HISTORIC AND DESIGN REVIEW COMMISSION

HDRC CASE NO: 2016-424
ADDRESS: 143 E LULLWOOD AVE
LEGAL DESCRIPTION: NCB 6535 BLK 15 LOT 39, 40 AND E 10 FT OF 38
ZONING: R-5
CITY COUNCIL DIST.: 1
DISTRICT: Monte Vista Historic District
APPLICANT: Jay Louden
OWNER: Sara Wasler, Sudipta Bhattacharya
TYPE OF WORK: Construct rear addition, fencing
REQUEST:

143 East Lullwood Addition

**Historic and Design Review Commission
Design Review Committee
Report & Recommendation**

Window Detail HP 702

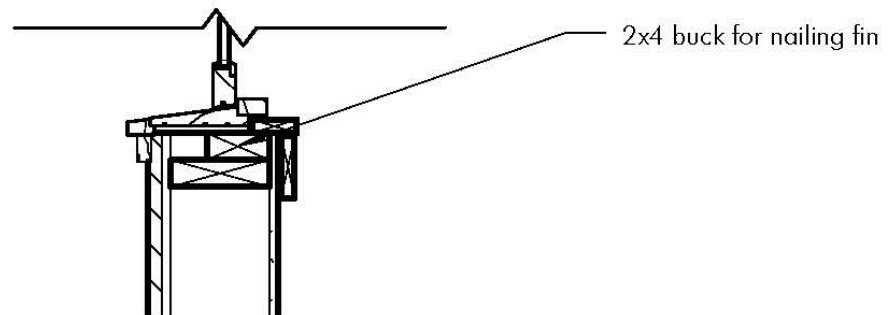
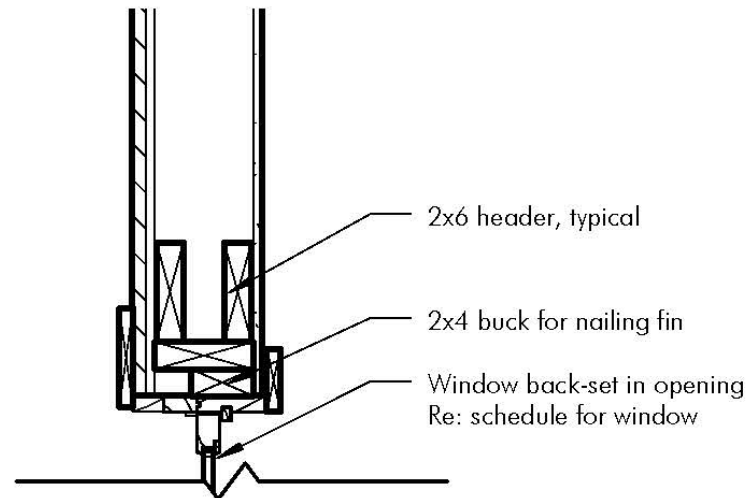
- g. **ARCHITECTURAL DETAILS** – The front slim 2 by 3 window over the front entrance has a decorative wrought iron window grill and the front right balcony has a decorative wrought iron railing. The applicant is proposing to install a decorative wrought iron window grill over a new wood one over one window to be installed on the south addition façade and install a pilaster horizontal banding detail 4’-8” above grade. According to the Guidelines for Additions 4.A.ii., details should be simple in design and compliment the character of the original structure. Staff finds that though the proposed decorative grill complements the structure, staff finds the design not an appropriate addition as it creates a false sense of history. Staff recommends the grill be omitted from the plans. Staff finds the pilaster details simple, is a reveal distinguishing the old from the new, and compliments the architectural style.

- 1. That the decorative wrought iron window grill be removed from the plans or modified to show a reveal.
- 2. If the applicant is considering the rehabilitation of the primary historic structure, staff recommends the applicant apply for Historic Tax Certification.

Rear Fence - Plan & Elevation HP 013

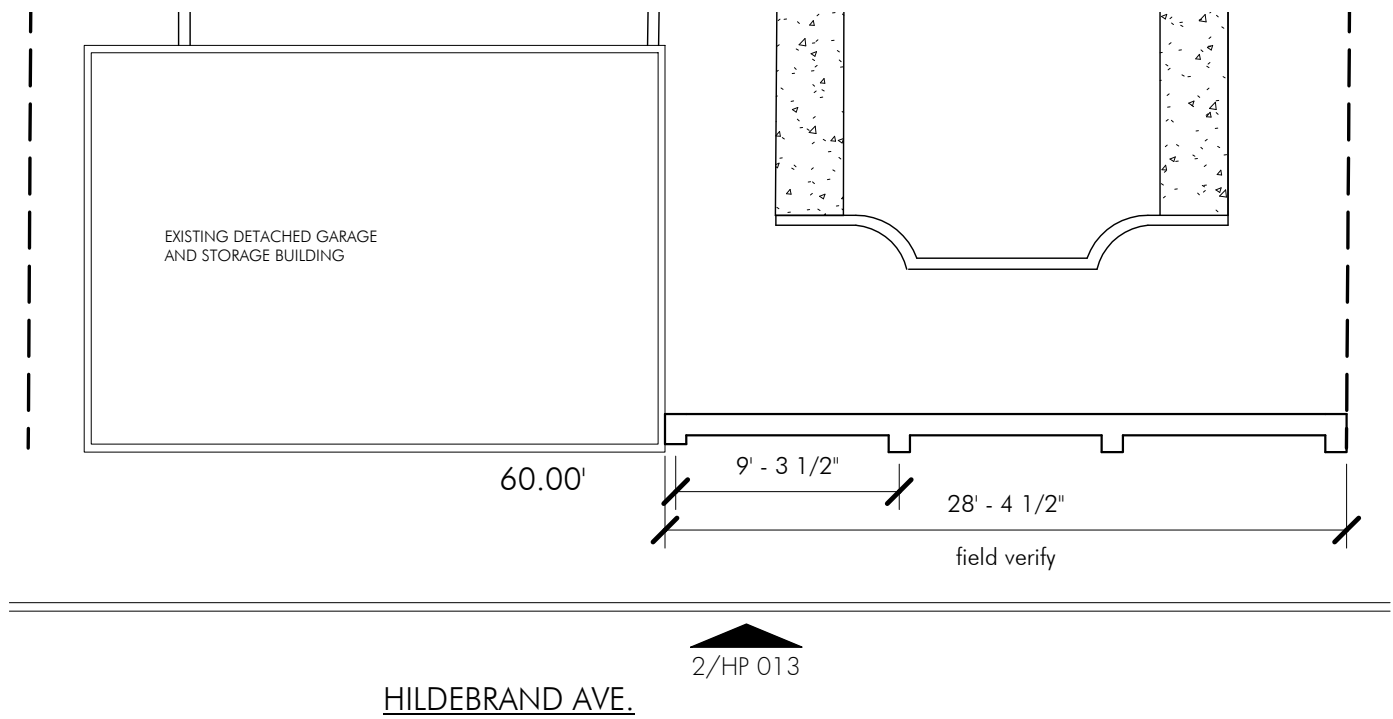
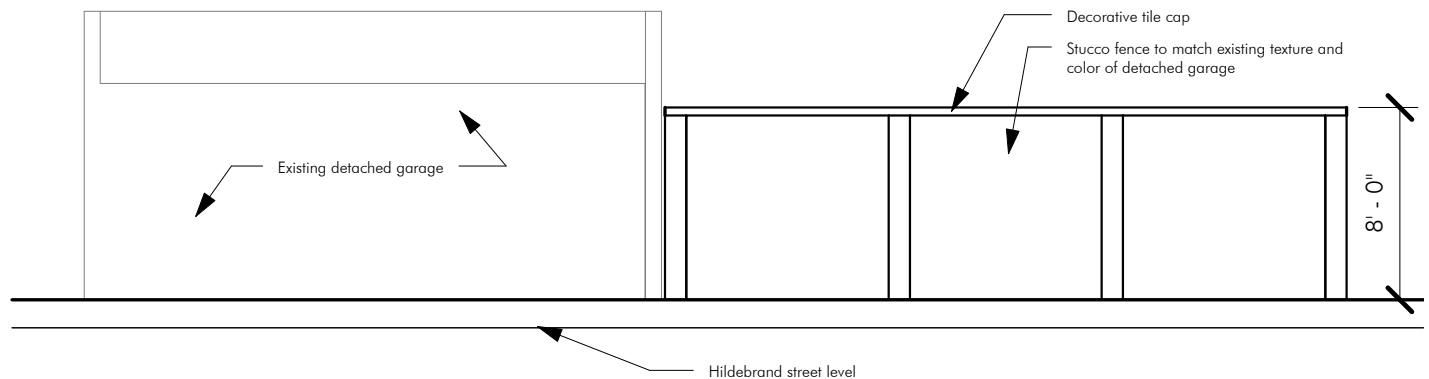
- i. **STUCCO FENCE** – There is an existing 6’ rear wood privacy fence along the rear property line. The applicant is proposing to remove the wood fence and install an 8” stucco fence with decorative tile cap with stucco texture and color matching the existing detached garage. According to the Guidelines for Site Elements, privacy fences should be in locations where they would historically exist, appear similar to other historic fences in the district, and use a material similar to other historic fences in the district. Staff made a site visit on October 21,

2016, and found that there are stucco fences in the district. Fences along Hildebrand and in the district are 8' in height. Staff finds the proposed 8' stucco fence appropriate in location and material, but finds that height not consistent with the Guidelines.

The final construction height of an approved fence may not exceed the maximum height as approved by the HDRC at any portion of the fence. Additionally, all fences must be permitted and meet the development standards outlined in UDC Section 35-514. The applicant will need to seek a variance from the Board of Adjustment for the additional fence height.

Retaining Wall - Plan & Elevation HP 015

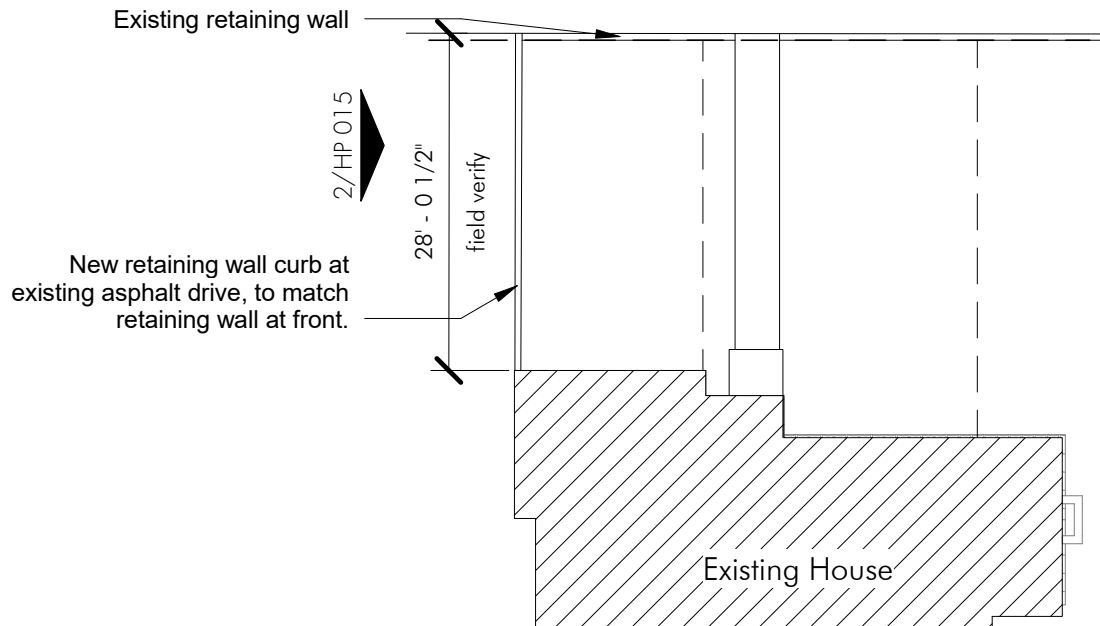
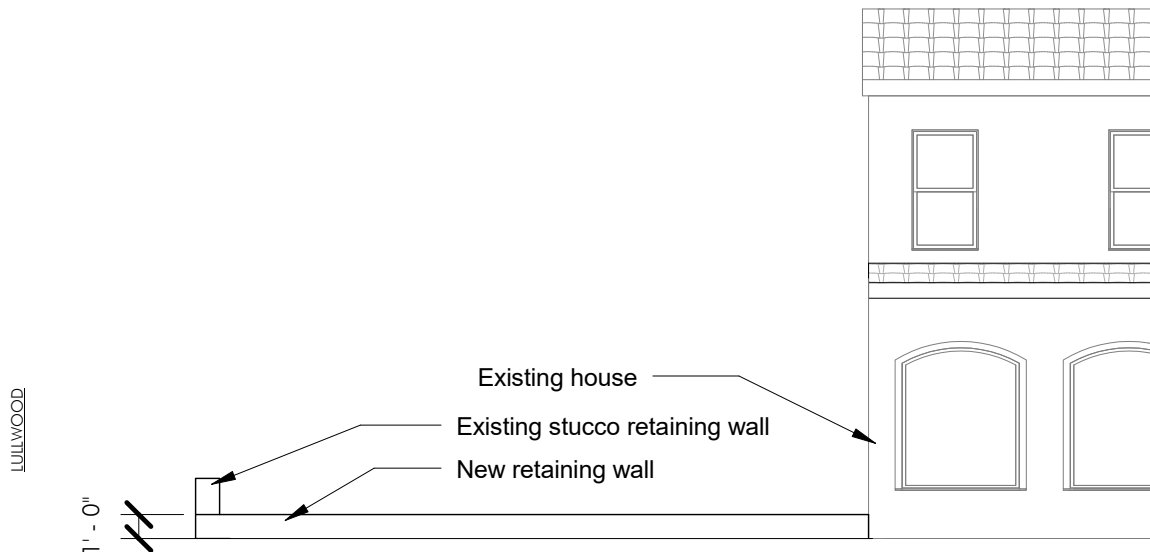
- j. **RETAINING WALL** – There is an existing 2' tall stucco retaining wall along the sidewalk parallel to Lullwood. The applicant is proposing to install 12" tall retaining wall in front yard along existing asphalt driveway. According to Guidelines for Site Elements, retaining walls should not be added unless absolutely necessary. Staff finds the retaining appropriate as it is consistent in design and material as the existing front wall.

Landscape Border Existing and New

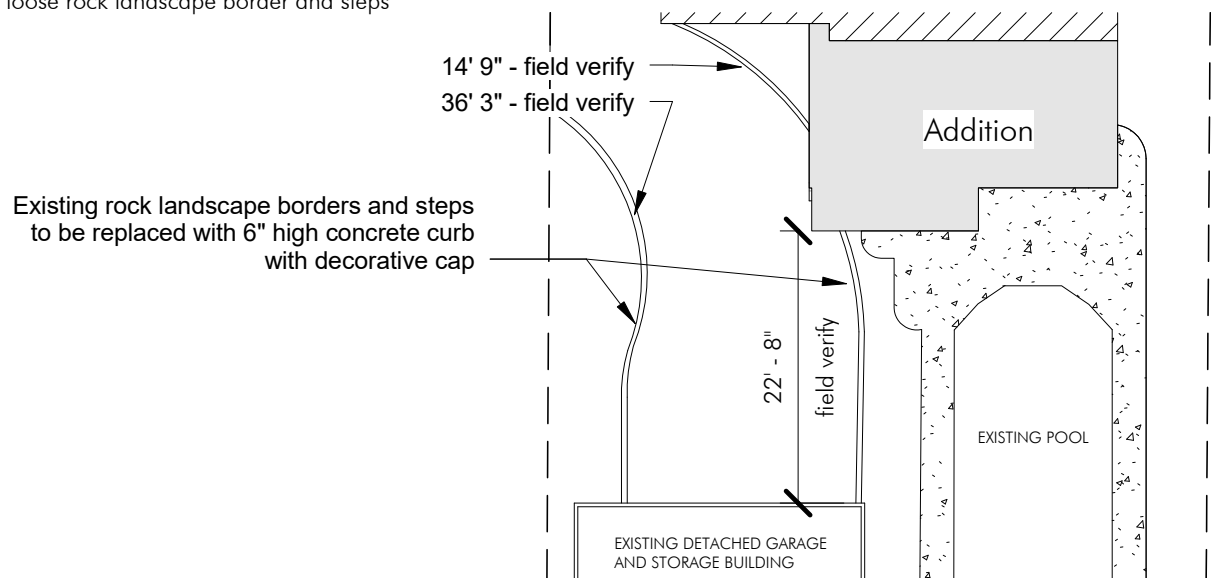
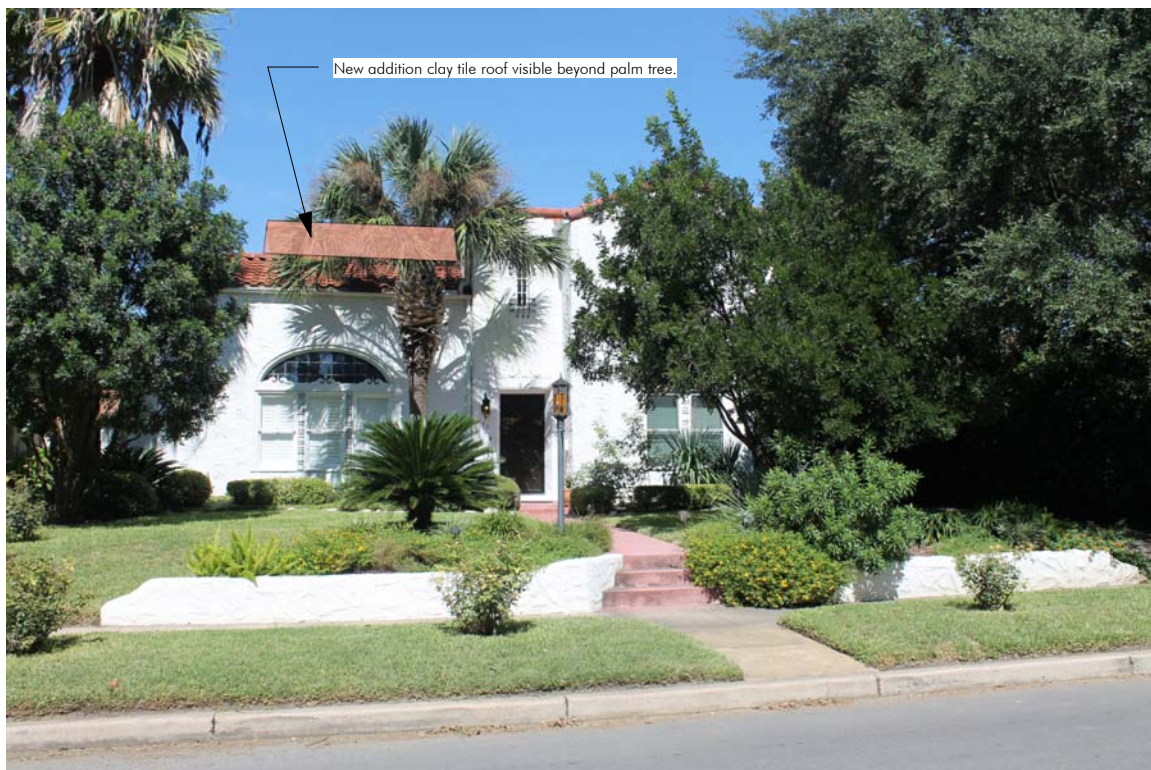
- k. **CURB** – There is an existing loose rock landscape border and steps to the patio. The applicant is proposing to remove those rocks and install a 6" tall concrete curb with a decorative tile cap. According to the Guidelines for Site Elements 5.C.ii., replace historic curbing in-kind. Staff finds the rock border not original to the rear drive, and the curb with a decorative tile cap an appropriate replacement.
